Georgetown Charter Township

Planning Commission Meeting Agenda

BALDWIN WOODS

RE: Baldwin Woods – Revised Preliminary PUD & Final Development Plan

SHEET NO: C-102

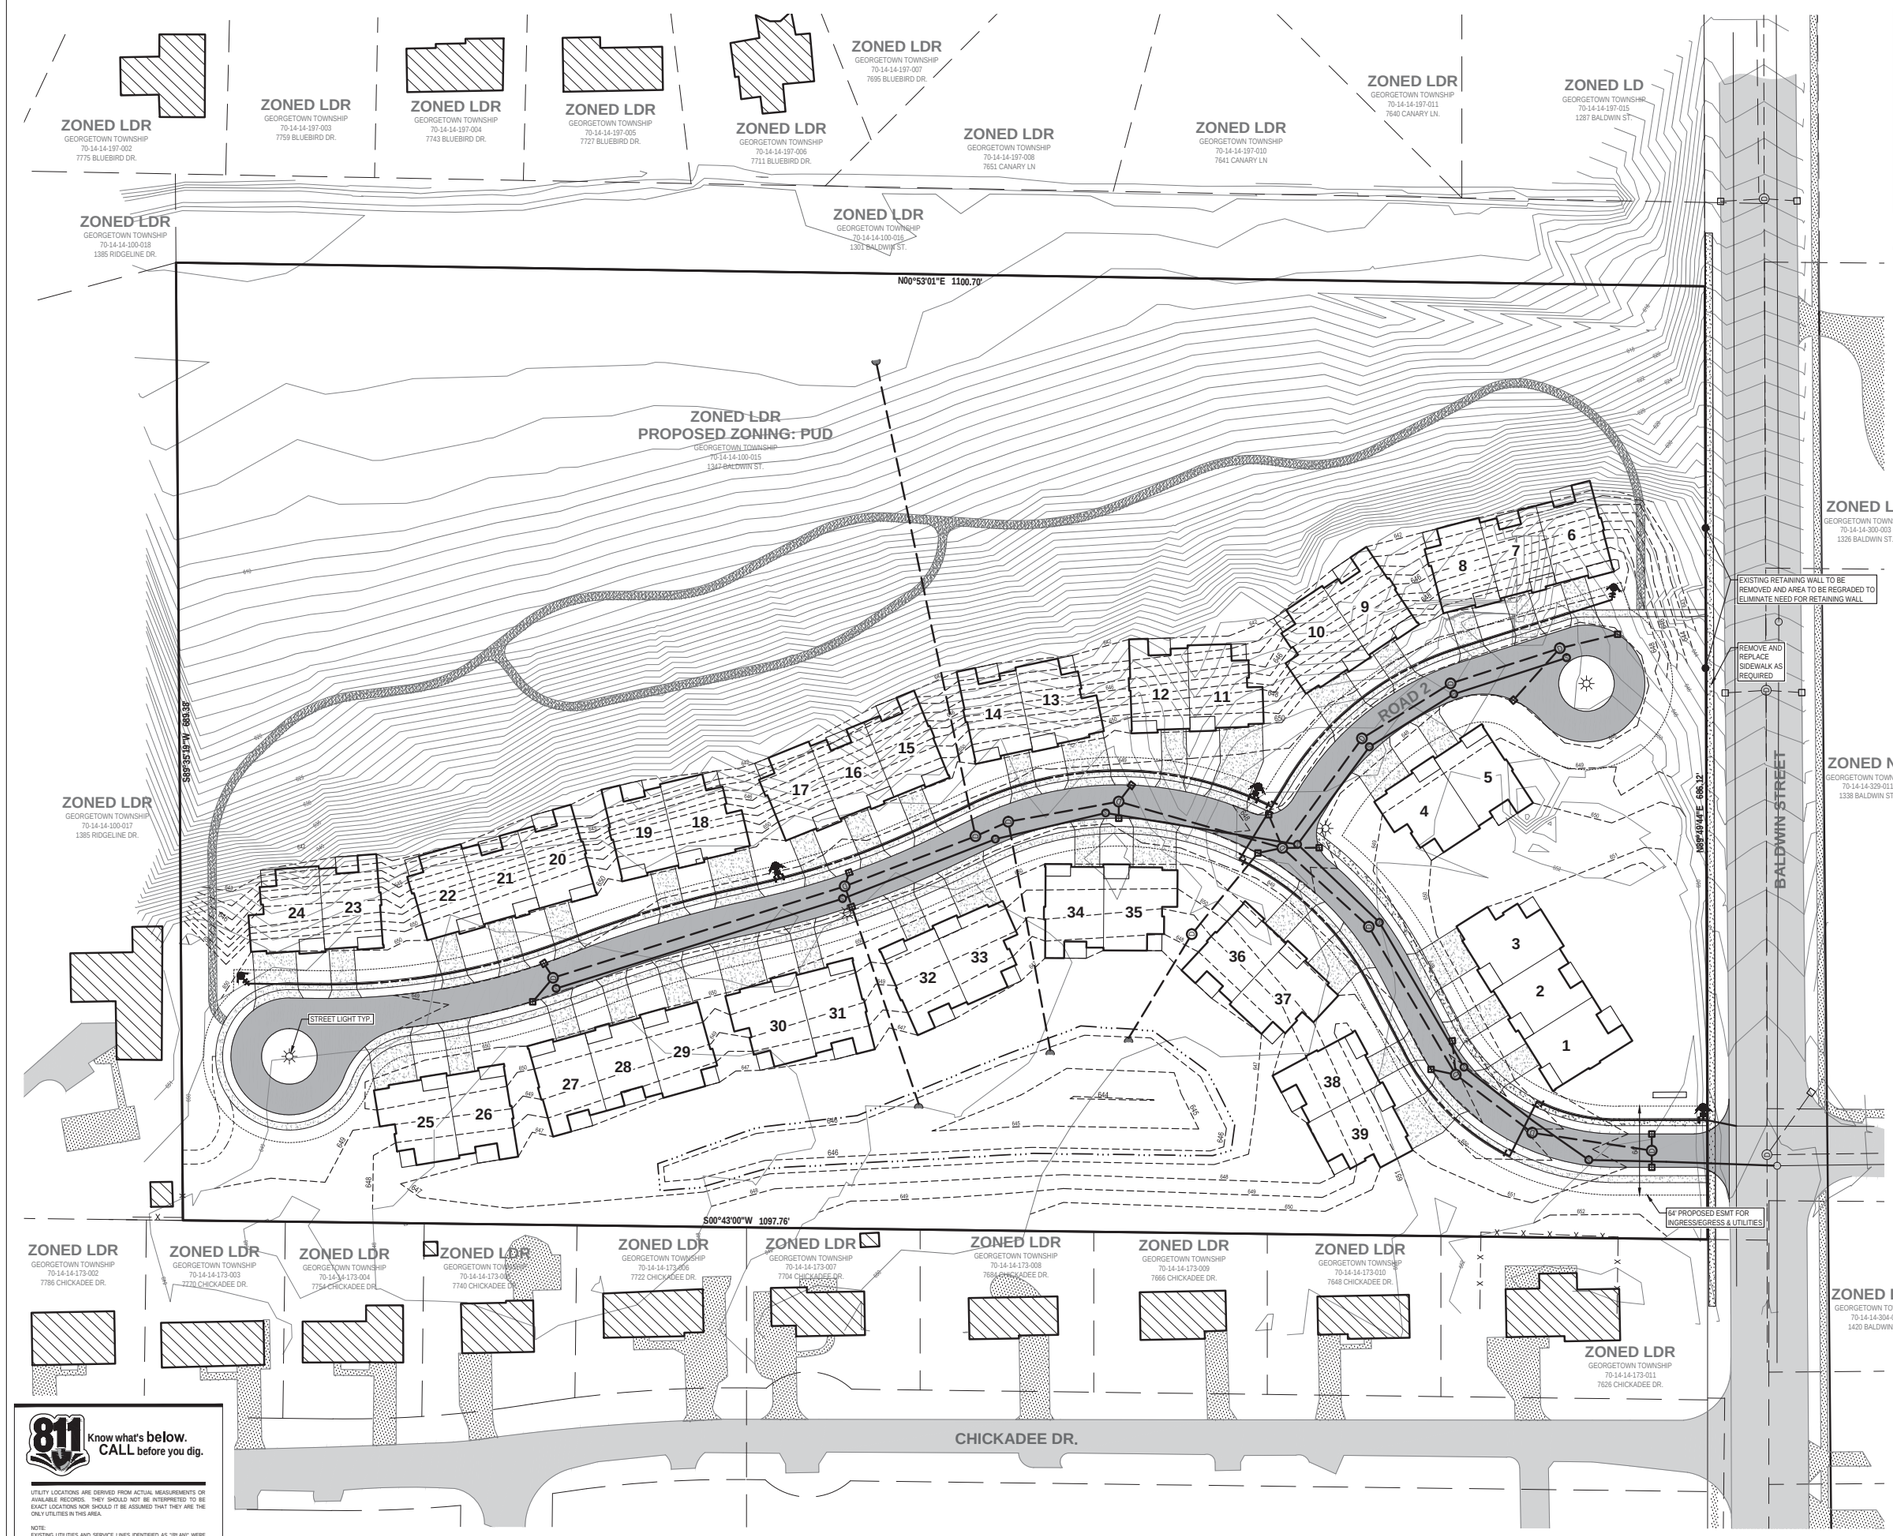
Comment: Interior sidewalks and pedestrian paths are proposed, along with sidewalk adjacent to Baldwin St. Indicate either on the plan or on a separate document that the hill to the sidewalk along Baldwin will be graded and the retaining wall removed.

Response: **See C-102, retaining wall to be removed and area to be regraded to eliminate the need for a retaining wall.**

ENTRANCE FEATURE CONCEPT

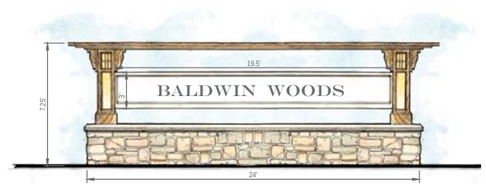
Comment: Please provide evidence that the sign coordinates with the architecture of the buildings.

Comment: Elevations were provided. Demonstrate how the proposed sign encompasses the same theme. Also, provide sign details, including dimensions from the centerline, height and square footage.

Response: **The entry feature signage will use design elements of the proposed condo buildings to create a cohesive appearance among all site structures. The entry feature signage design is to use a common color scheme, material usage as well as architecture style as the condos. For instance, the wood portions of the sign are to be treated in the same manner as the wood elements of the condos. The same stone used on the condo walls will be used to construct the base of the sign. Architectural features such as the corbels in the peaks of the condos were repeated on the posts of the entrance sign to reinforce the unified character of all proposed structure.**

Response: **Sign details, including dimensions, are now depicted in the plan set.**
